# **INDEPENDENT ENVIRONMENTAL AUDIT**

## **WOODLAWN BIOREACTOR AND CRISPS CREEK INTERMODAL FACILITY**

Revision **Final**  
Date **24/05/2021**  
Made by **Emily Rowe & Vanessa White**  
Checked by **Victoria Sedwick**  
Approved by **Victoria Sedwick**  
Description **Independent Environmental Audit of Woodlawn  
Bioreactor and Crisps Creek Intermodal Facility**  
Ref: **318001112**

Figure 4.1 Schematic representation of modelled dams in GOLDSIM

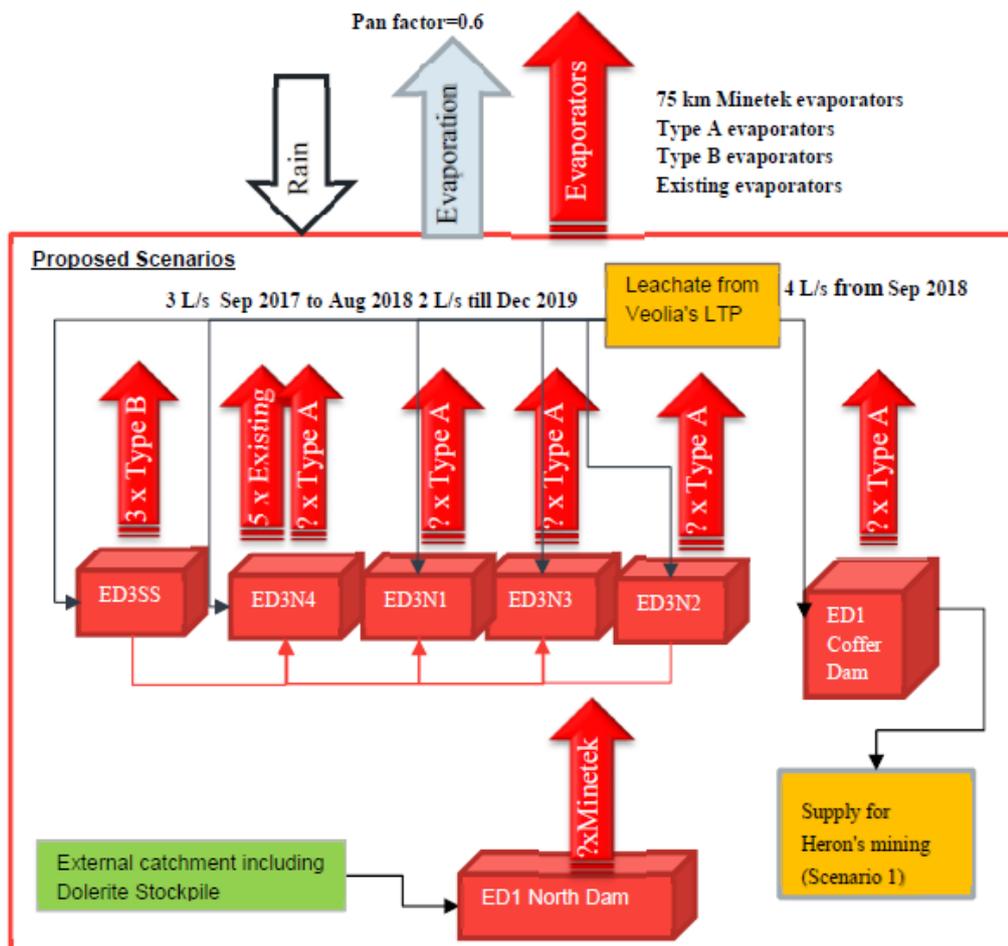
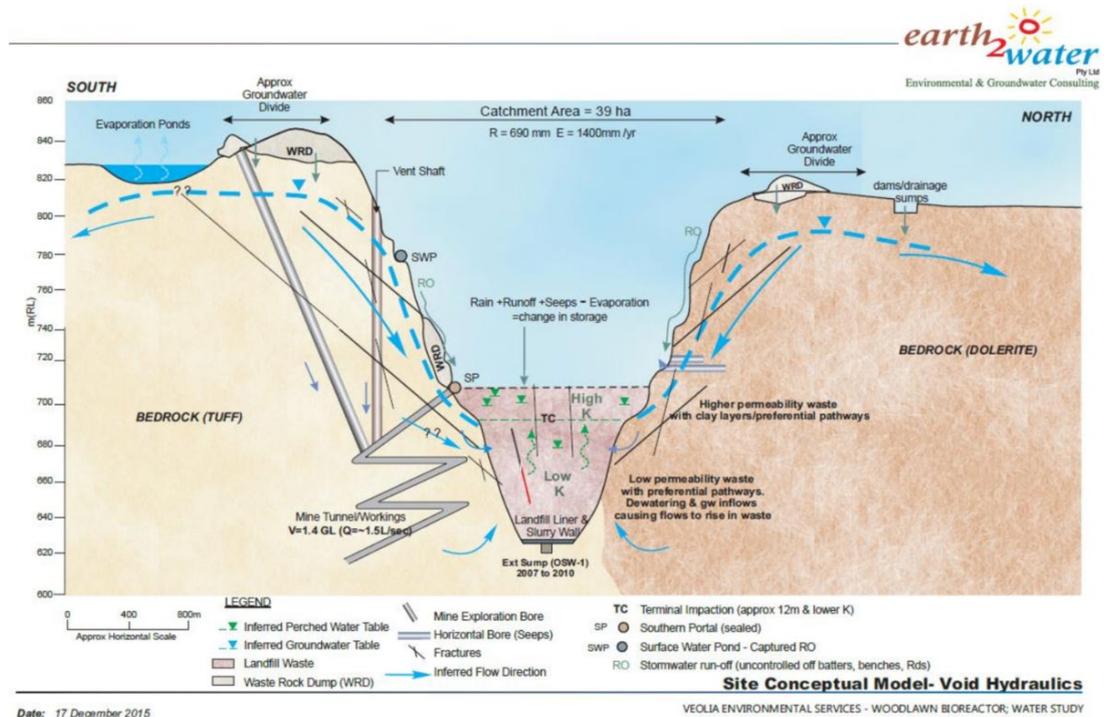
Based on consultation with the EPA and Water NSW for this Audit, they are primarily concerned about the build-up of leachate in the Bioreactor void and gave the Auditors the impression that the water balance modelled the Bioreactor void, as opposed to the evaporation dams. The Auditors suggest that Veolia consult with the EPA, Water NSW and the Department to ascertain their expectations in relation to the water balance model and whether the model and associated condition(s), should be modified to better meet their expectations.
